Sea Link

Document 9.86 Applicant's Comments on Other Submissions Received at Deadlines 3 and 3A

Planning Inspectorate Reference: EN20026

Version: B
February 2026

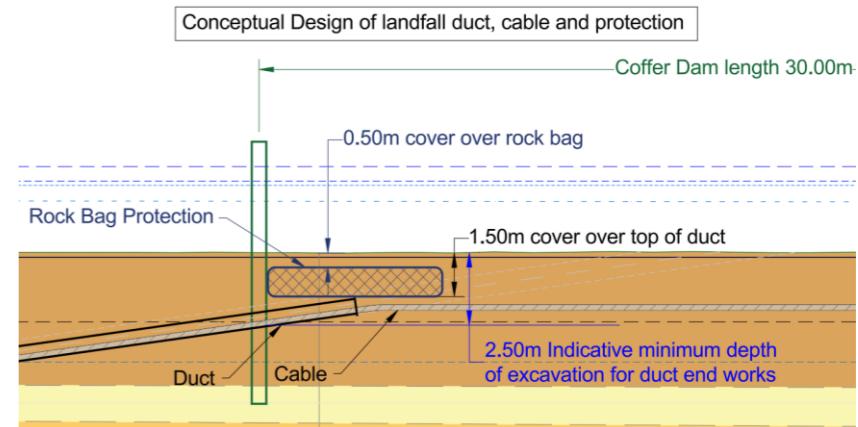
5 1.9.23	Natural England notes that the WCS cofferdam parameters at each HDD exit pit are as follows: 10-15 m in length, 3-5 m width, and 2 m depth below seabed level. However, in [REP1-108] it is stated that the assessed WCS assumes the construction of smaller cofferdams (maximum length 30m, width 5m, piling depth approx. 6m below ground level and 2m excavation depth within the cofferdams) on four separate occasions. Therefore, we remain concerned, that the increased WCS cofferdam size represents an increase not only in intertidal sediment disturbance, but also blockage potential, which could modify waves and/or current flows around the structure, affecting sediment transport, and leading to morphological change.	Natural England advises that the EIA should be updated accordingly, taking into account the larger cofferdam size proposed, seabed disturbance area and volume, blockage potential, and scour potential. Duration and timing of the cofferdam installation and presence should be taken into account.	<p>Application Document 9.13 (B) Pegwell Bay Construction Method Technical Note [REP2-011] explains that:</p> <p>The assessed worst-case scenario assumes the construction of smaller cofferdams (maximum length 30 m, width 5 m, with piling depth approximately 6 m below ground level and excavation depth within the cofferdams to a depth below seabed of 2 m) on four separate occasions during HDD drilling and duct installation. Based on previous works, it is anticipated it will take up to seven days to install a cofferdam around a single HDD exit pit. Only one cofferdam will be installed at any one time, and while the total duration for all cofferdams in place is 120 days, each cofferdam is expected to be in place for only 30 to 60 days. Therefore, any impact will be temporary.</p> <p>(Application Document 9.13 Pegwell Bay Construction Method Technical Note [REP2-011]).</p>

Ref Section / Para	Key Concern and/or Update	Natural England's Advice to Resolve Issue	Applicant's Comments
			<p>The cofferdams will be located essentially at Mean Sea Level (MSL) (0.20 m OD elevation, MSL is approximately 0.15 m OD. Therefore, for 50% of the time the area surrounding the cofferdam will be dry and no scour will be taking place. Further, Application Document 9.20.2 Landfall Sediment Modelling Report Pegwell Bay [PDA-038], explains that peak current velocities in Pegwell Bay are less than 0.1 m/s, which is well below the flow rates associated with any significant scour depths.</p> <p>On this basis and taking into account the larger cofferdam dimensions than previously considered, the magnitude of any change in relation to the cofferdam on nearshore seabed morphology (and the associated flow dynamics) will be small. This results in a minor effect which is not significant.</p> <p>Application Document 6.2.4.1 Part 4 Marine Chapter 1 Physical Environment has been submitted at Deadline 4.</p>

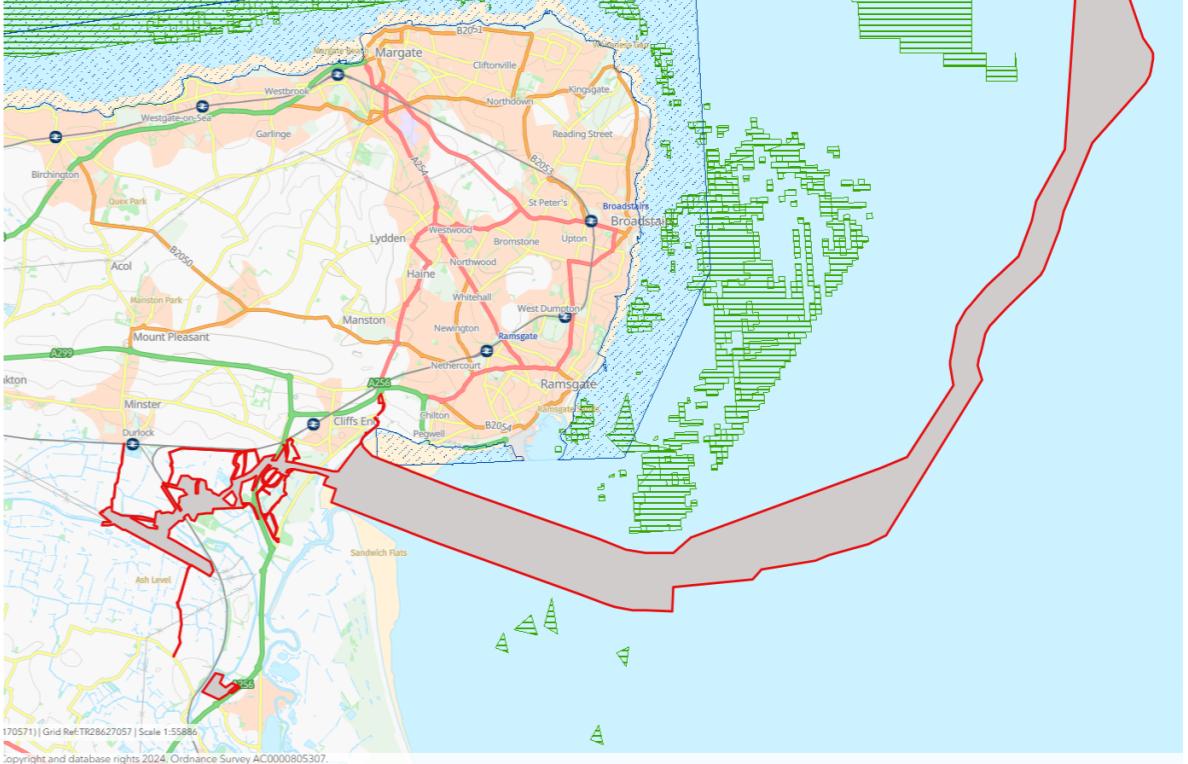
7 1.2.3	<p>The Planning Statement (Application Document 7.1 Planning Statement [AS-057]) provided an assessment on each of the Special Qualities Indicators. However, Natural England notes that the baseline for the Special Qualities from the 2016 published document was not presented within this assessment. Those points relevant to landscape and visual matters were included in the landscape baseline appendix (Application Document 6.3.2.1.B ES Appendix 2.1.B Landscape Baseline [APP-096]).</p> <p>We advise that the referenced Planning Statement does not provide a detailed appraisal of the impact of the scheme on the special qualities of the Protected Landscape.</p> <p>In addition, the referenced Planning Statement refers back to Document: 6.3.2.1.C Part 2 Suffolk Chapter 1 Appendix 2.1.C Landscape Designation and Landscape Character Assessment – Suffolk for a full assessment. We continue to advise that Document 6.3.2.1.C does not appear to include a full assessment of impacts on special qualities as set out in the Management Plan.</p> <p>This is because the table does not clearly include the full suite of Special Quality indicators and accompanying narrative/evidence informing assessment parameters and evidence to substantiate conclusions made.</p>	<p>Natural England advises that the planning statement and relevant documents are updated accordingly.</p>	<p>An addendum to the Planning Statement is being submitted at Deadline 4 (Application Document 9.94 Planning Statement Addendum submitted at Deadline 4) to include the Special Qualities Indicators baseline and further detail relating to the assessment.</p> <p>Appendix A 1LVIA9 Natural Beauty Indicators and their Sub-Factors contained within Application Document 9.73.1 Applicant's Responses to First Written Questions – Appendices [REP3-070] provides further detail on how the sub-factors of the Natural Beauty Indicators have the potential to be affected by the Proposed Project. This is a combination of information from Table 2.1 within Application Document 6.3.2.1.C ES Appendix 2.1.C Landscape Designation and Landscape Character Assessment [APP-097] with further clarity provided on the potential effects arising from the Suffolk Onshore Scheme for each of the sub-factors listed within the LDA Design Suffolk Coast and Heaths Area of Outstanding Natural Beauty (AONB) Natural Beauty and Special Qualities Indicators V1.8 2016 document. This demonstrates that the non-significant effects reported within Table 2.1 of Application Document 6.3.2.1.C ES Appendix 2.1.C Landscape Designation and Landscape Character Assessment [APP-097] at construction and operation (and maintenance) remain justified.</p>

Ref Section / Para	Key Concern and/or Update	Natural England's Advice to Resolve Issue	Applicant's Comments
	<p>As previously advised the detailed/comprehensive assessment of the impact of the project on what makes the receiving landscape special is not clearly presented.</p> <p>The assessment relies on temporality of impact which we continue to advise requires substantiation.</p> <p>We continue to advise that the conclusion that that the effect is localised/small scale again is not clearly substantiated and is not applicable to LVIA assessment as the impact on place is key.</p> <p>This evidence is crucial to the assessment because it has been used to moderate the Applicants conclusion on the magnitude of effect on special qualities.</p> <p>Natural England does not agree that impacts in relation to small geographical extents can moderate impact to statutory purposes.</p>		
8 2.1.1	<p>Natural England notes that the AONB and its setting were considered in the early stages of the routeing and siting for the Suffolk Onshore Scheme. However, it is not clear how the impact of the project on the setting of the Protected Landscape has been assessed.</p>	<p>Natural England advises that further detail is included on the impact of the scheme in its entirety, including impact of trenchless crossings into the setting. This is not limited to the location of the converter station/landing site.</p>	<p>The Landscape and Visual chapter (Application Document 6.2.2.1 Part 2 Suffolk Chapter 1 Landscape and Visual [APP-048]) refers to the 'Development in the setting of the Suffolk Coast & Heaths Area of Outstanding Natural Beauty (AONB) Position Statement' document published by the Suffolk and Essex Coast and Heaths National Landscape Partnership (SECH Partnership) in 2015. This notes that the setting of the SECHAONB is not fixed and it is specific to the development as to whether it would influence the Natural Beauty and Special Qualities Indicators of the AONB.</p> <p>Part of the Proposed Project is located within the SECHAONB and the potential for significant adverse effects on the setting is very limited due to the temporary nature of the construction activity and the positioning of the Suffolk Converter Station site located away from the SECHAONB to limit potential effects on the setting. The assessment therefore focuses on the direct effects with consideration of the setting with respect to indirect effects. As noted within the assessment contained within Application Document 6.3.2.1.C ES Appendix 2.1.C Landscape Designation and Landscape Character Assessment [APP-097] setting, as an indirect effect, is addressed for each Natural Beauty Indicator where relevant.</p> <p>The indirect effects on the SECHAONB are limited, especially at operation (and maintenance), as they are restricted to intervisibility with the cable laying barge out at sea and as the HVDC cable laying continues to the north-west through the landscape outside of the SECHAONB boundary. This includes:</p> <p>A temporary effect on the scenic quality of the SECHAONB related to offshore views from the coastline;</p> <p>A temporary effect on the relative wildness of the SECHAONB relating to the introduction of elements of uncharacteristic machinery and noise; and</p>

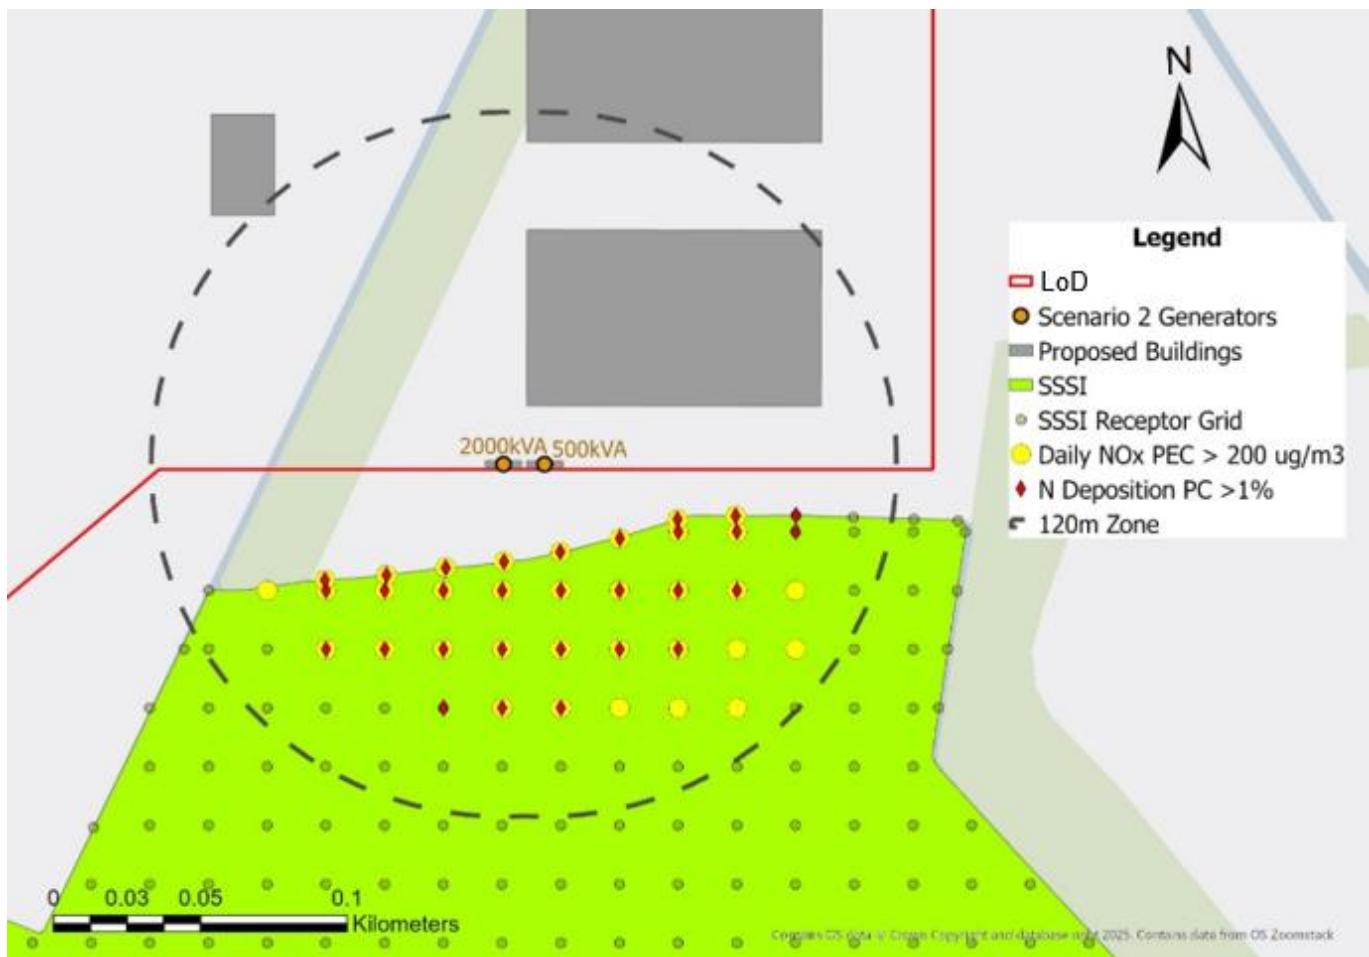
A.7.46 For daily mean NOx, the largest PC predicted is 389% of the critical level, and the largest PEC predicted exceeds the critical level.

A.7.48 The results show that if both generators were positioned close to the SSSI then there would be potential for significant air quality effects on the SSSI. The receptor grid for the SSSI has been used to determine how far from the generators there could be potentially significant effects. **Appendix Plate A.2 Area of Modelled Exceedance of Thresholds** shows the grid points where exceedances of the daily mean NOx critical level are predicted (Daily NOx PEC $> 200 \text{ ug/m}^3$), and where the N deposition PC exceeds the 1% critical load for N deposition.

A.7.49 The results show that the area of potential significant effects extends up to approximately 100 m from the generators, and so if the generators were positioned at least 120 m from the SSSI, there should be no significant effects. A 120 m zone around the generators is also presented in **Appendix Plate A.2 Area of Modelled Exceedance of Thresholds**, to help demonstrate this, as it shows there are no threshold exceedances within this area. This is also partly demonstrated by Scenario 1, as both generators are located more than 120 m from the SSSI, and there are no potentially significant effects on the SSSI when considering the thresholds in **Appendix Table A.5 Thresholds for Potential Significant Effects**.
